# Access Compliance Report

### (Curb Ramps)

Intersection ID: 12305	Main Street: E_5TH_ST	Cross Street: N_COLLEGE_ST	Location: E
ADA ID: 329003097413	Ramp Type: Perp	Initial Pass/Fail: Pass	Overall Compliance: No
Severity Score: 5			
Codes/Mitigation Info/Possible Solution		Field Measurements/Component Compliance

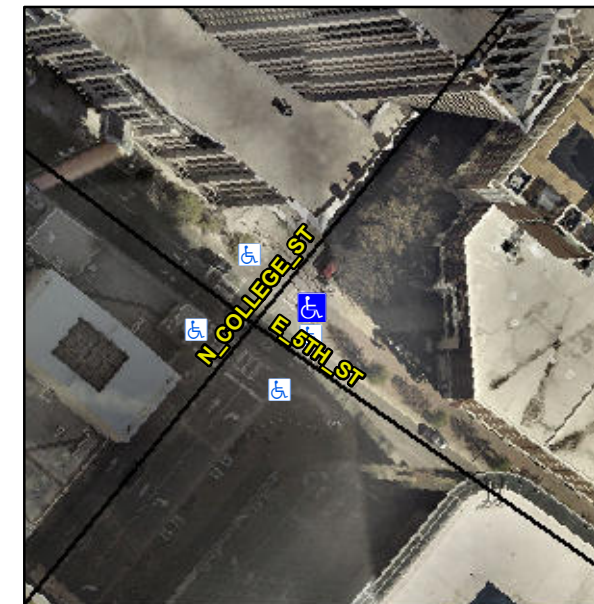
**Not Found, R304.2.3**

Compliance	Description	Data	Compliance	Description	Data
N/A	Ramp Length (in)	43.0	Yes	Ramp Slope (%)	2.1
Yes	Ramp Width (in)	48.0	Yes	Ramp XSlope (%)	0.1
N/A	Flare Type LT	Sloped	No	Flare Type RT	N/A
N/A	Flare Slope LT (%)	5.1	N/A	Flare Slope RT (%)	N/A
N/A	Flare Traversable LT?	Yes	N/A	Flare Traversable RT?	No
Yes	Landing Length (in)	48.0	Yes	DWS Provided?	Yes
Yes	Landing Width (in)	48.0	Yes	DWS Contrast?	Yes
Yes	Landing Slope (%)	1.7	Yes	DWS Length (in)	24.0
Yes	Landing X Slope (%)	0.1	Yes	DWS Full Width?	Yes
N/A	Landing Curb? (Y/N)	No	Yes	DWS Offset (in)	0.0
N/A	Shared Landing?	No			
Yes	Gutter Ponding?	No	Yes	Gutter Slope (%)	1.0
Yes	Gutter Lip Ht (in)	0.0	Yes	Gutter X Slope (%)	0.6
N/A	Painted X Walk1?	Yes	N/A	Painted X Walk2?	N/A
	X Walk 1 Direction	To NW		X Walk 2 Direction	N/A
N/A	X Walk 1 Width (in)	108.0	N/A	X Walk 2 Width (in)	N/A
	X Walk 1 Slope (%)	2.6		X Walk 2 Slope (%)	N/A
	X Walk 1 X Slope (%)	2.4		X Walk 2 X Slope (%)	N/A

**Remove & Replace Entire Ramp.**
